BARRATT HOMES

Site:-
Sinah Lane
Hayling Island

Drawing Title:-
HIGHWAY LAYOUT REVIEW
SHEET 1 OF 2

Drawing No.
BSO/E4513/016 G

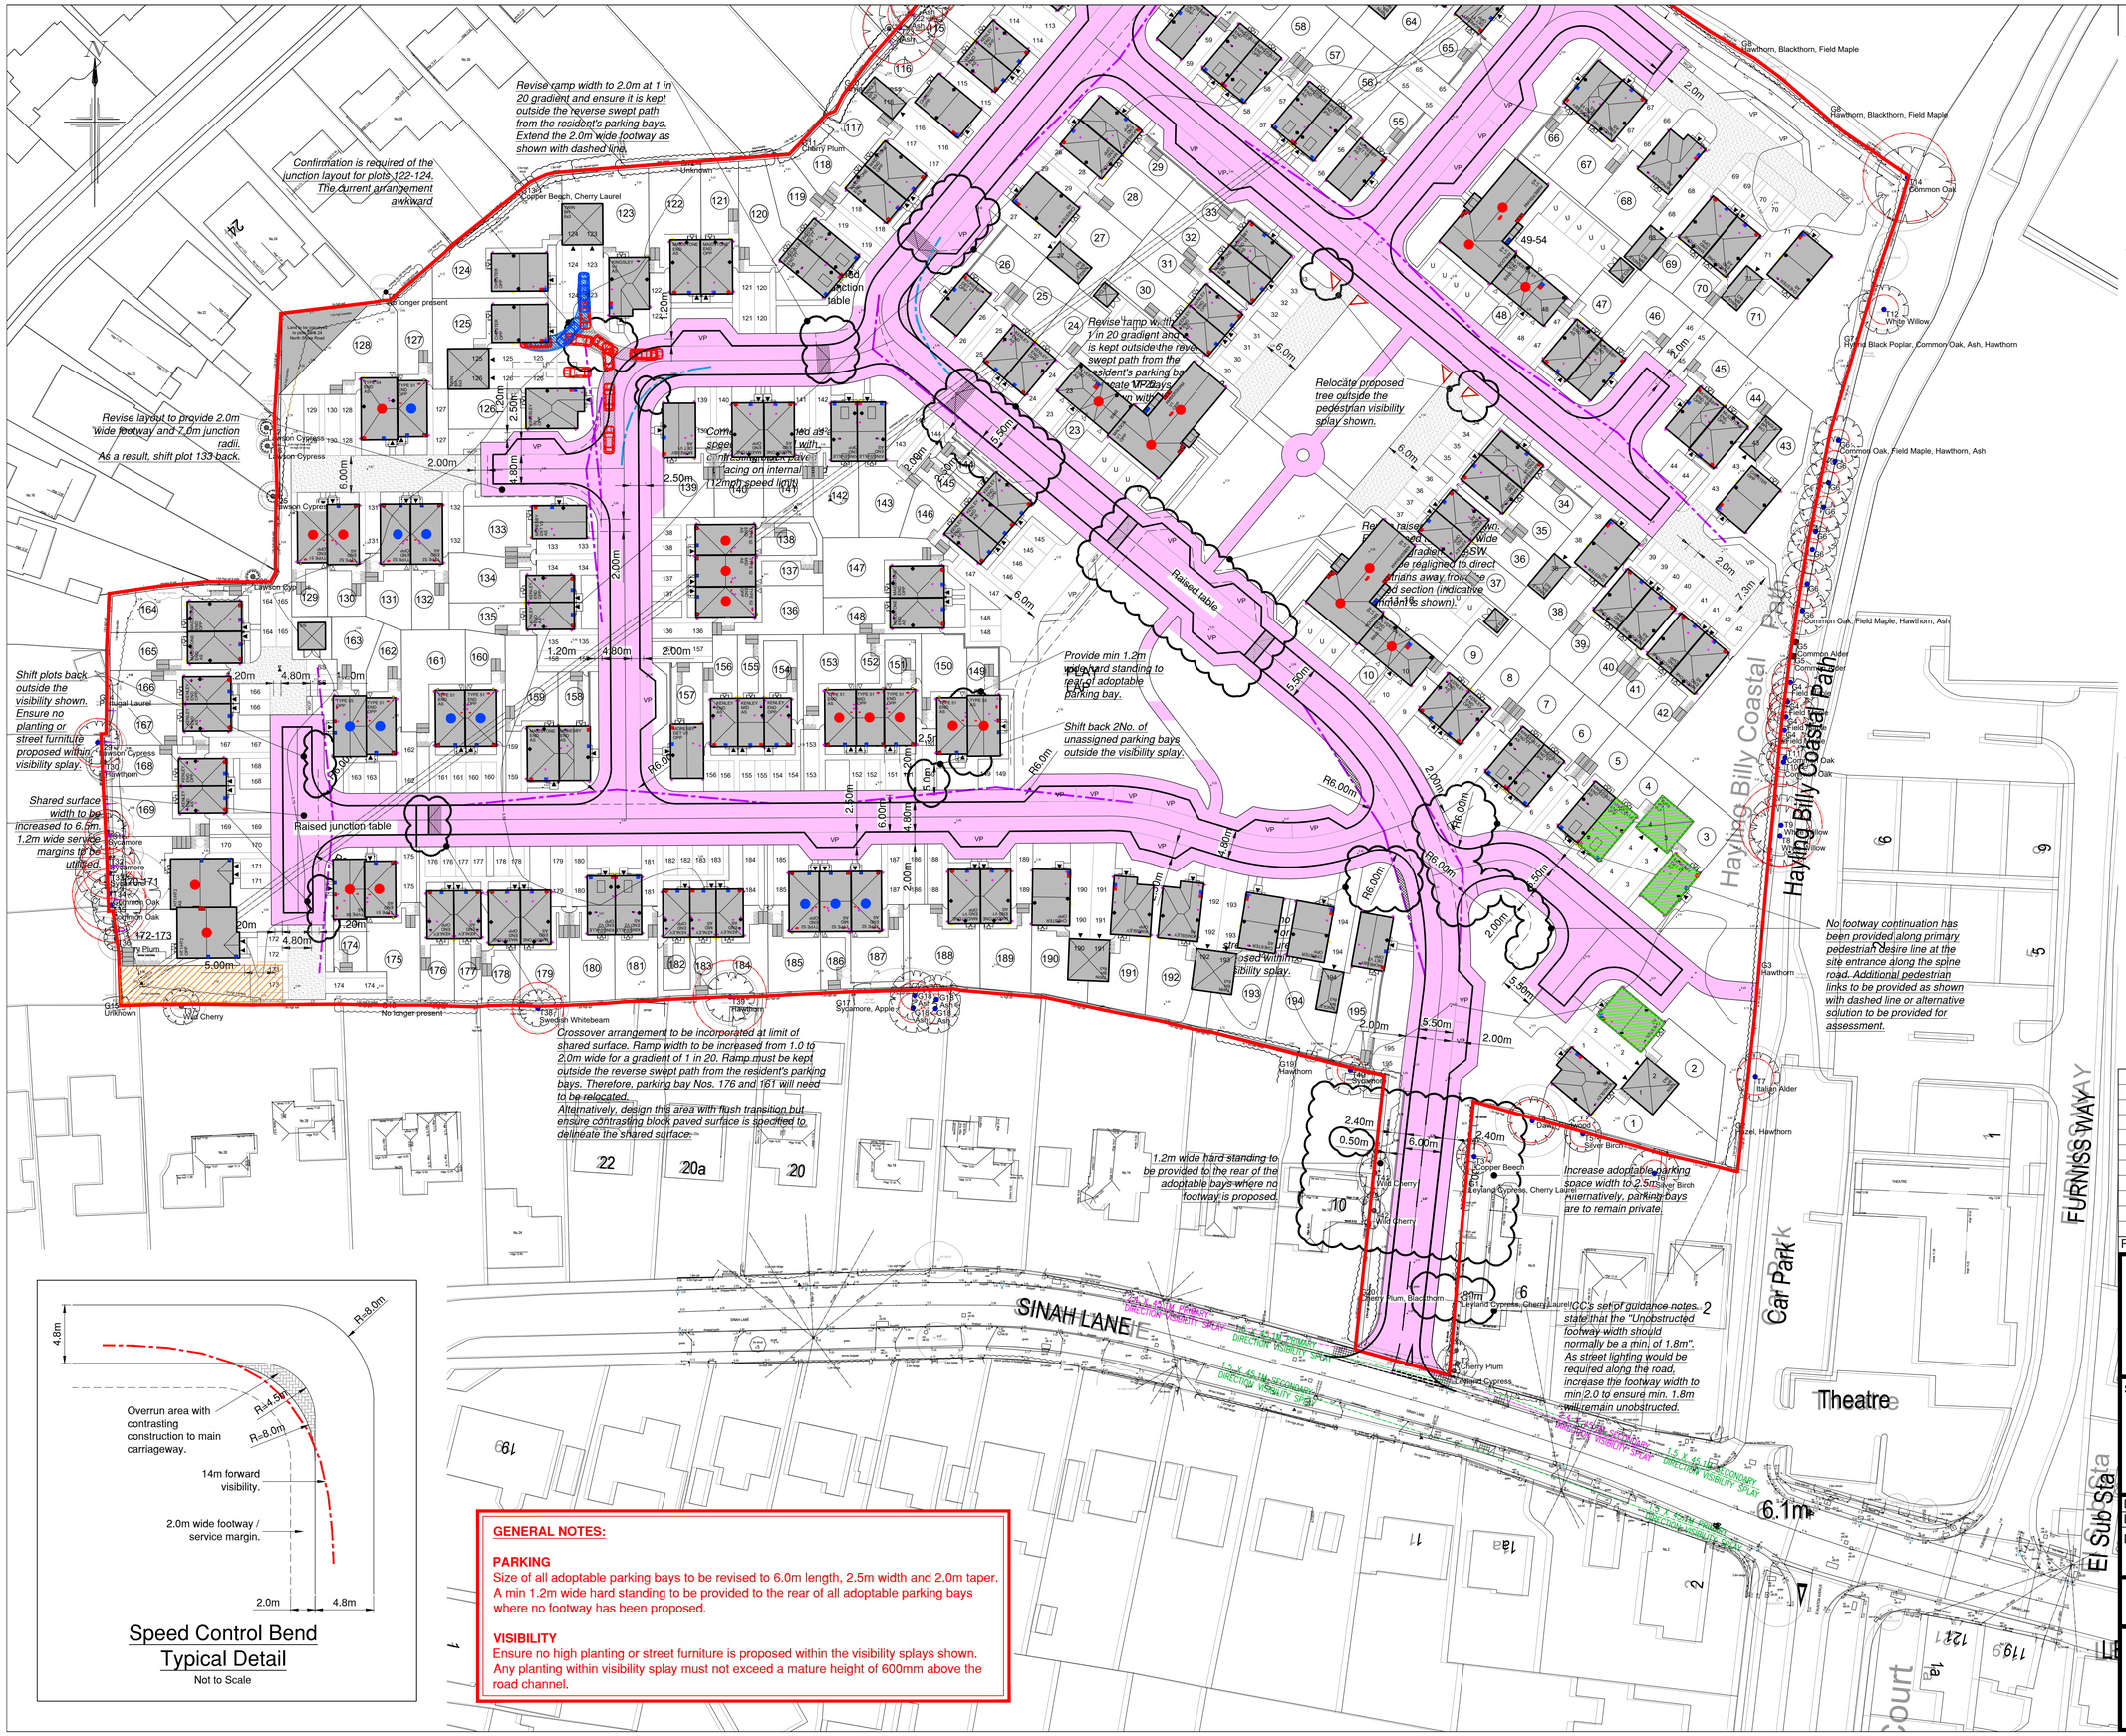
Size of all adoptable parking bays to be revised to 6.0m length, 2.5m width and 2.0m taper. A min 1.2m wide hard standing to be provided to the rear of all adoptable parking bays where no footway has been proposed.

Ensure no high planting or street furniture is proposed within the visibility splays shown. Any planting within visibility splay must not exceed a mature height of 600mm above the road channel.

5. 0.5m adoptable service margins are to be introduced between highway edge and adjacent private parking bays which may require plots to be moved back and garden sizes to be reduced to allow for the margin. *Alternatively a 1.0m easement should be provided at the back of the highway edge. Preferred method subject to consultation with Hampshire County Council.*

6. 0.5m minimum adoptable service margins required within verges from edge of carriageway. *Alternatively a 1.0m easement should be provided at the back of the highway edge. Preferred method subject to consultation with Hampshire County Council.*

7. Minimum road widths to be 3.7m to allow for Fire Tender access.
8. A 1.2m - 2.0m footway will be required on the inside corner of speed control bends where used in shared surface areas.
